Subject: F53 Bill Length Errors with Polymer Notes

Update B: Added information regarding Cassette Width setting.

Update A: A second issue was discovered (belt in wrong position) and documented below.

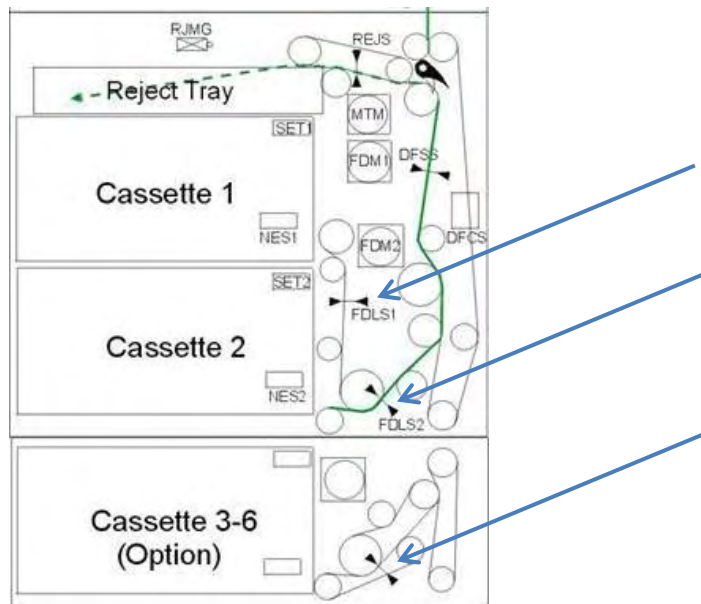
One cause has been found to be with the sensors in the F53 not being able to properly sense the windows in the notes because they are dirty. While the reduced sensitivity of the sensor due to dust/dirt may not be apparent with the use of standard paper notes (solid), the introduction of the Polymer notes with windows required more sensitivity of the sensor to recognize the partially transparent window.

Any geography that begins using Polymer notes for the first time should anticipate these sensors needing to be cleaned on any units that have been installed and operational. In the illustration below, the FDLS sensors (especially #2) are the most critical for this error, though during the Service or Preventive Maintenance all sensors and belts should be cleaned. This illustration below does not show the exit transport (which is different in each version of U-Scan). There is also a BPS sensor in the exit transport that should be cleaned.

**F53 Rear
Belt in Wrong Position**

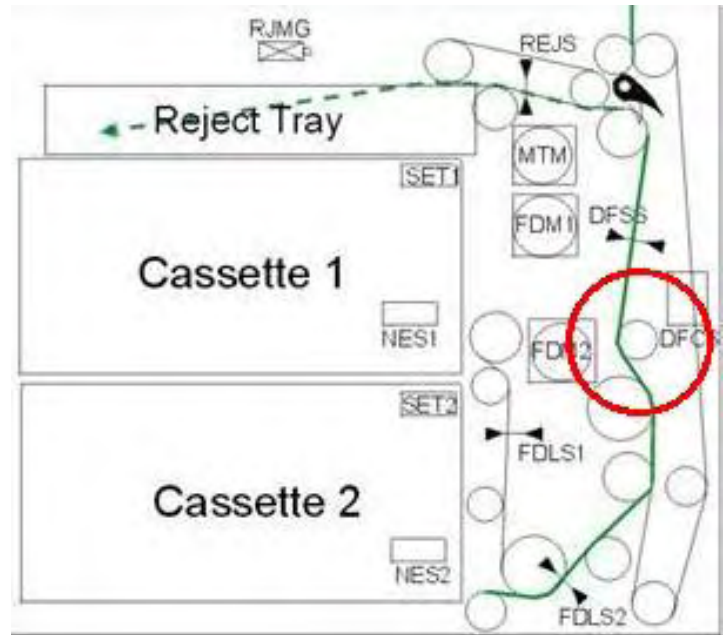
When a customer clears a potential jam in the rear of the unit, it is possible that they inadvertently pull a specific belt out of position. While the unit may appear to continue to function, the bill timing may be affected enough to cause some issues. This is most prevalent from Cassette #2 and with the use of Polymer Notes.

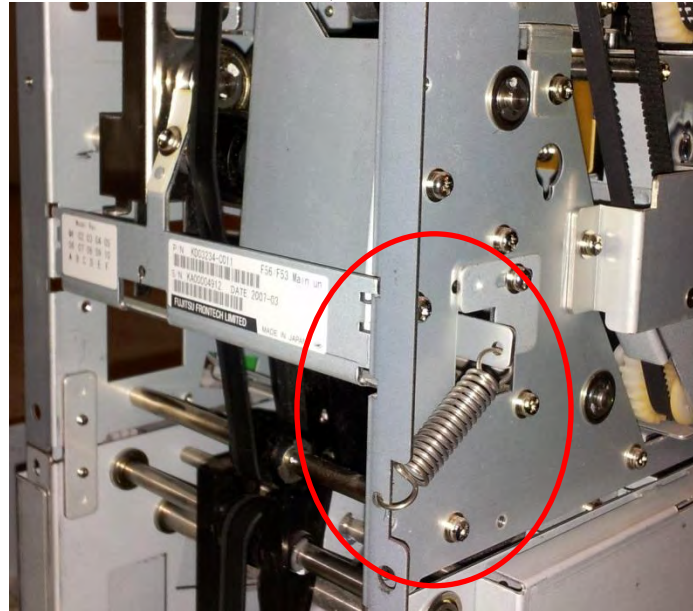
Also make sure the spring (shown below with cover removed) is installed and holds tension on the wheel.

Cassette Width Setting

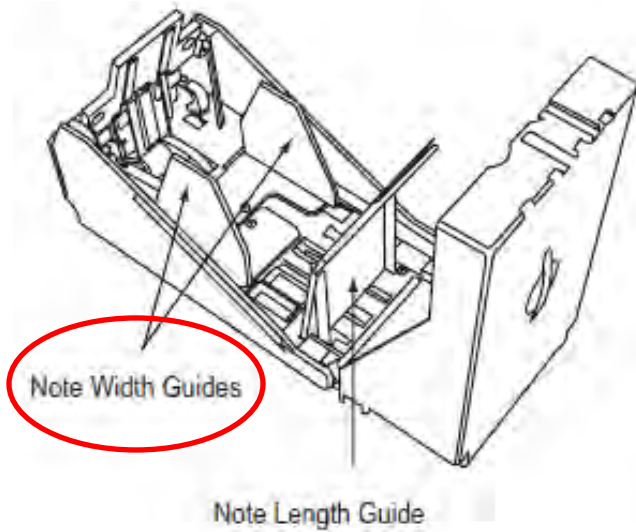
The published dimensions of the new Canadian notes is slightly different that actual measured value of the production minted notes, was documented as 69mm width, is actually 69.85mm. Following testing of the new production notes, it has been found that for optimum performance, the Cassette Note Width settings should be set to 72 on each side (each mark = 4).

3rd Mark from '60' on each side
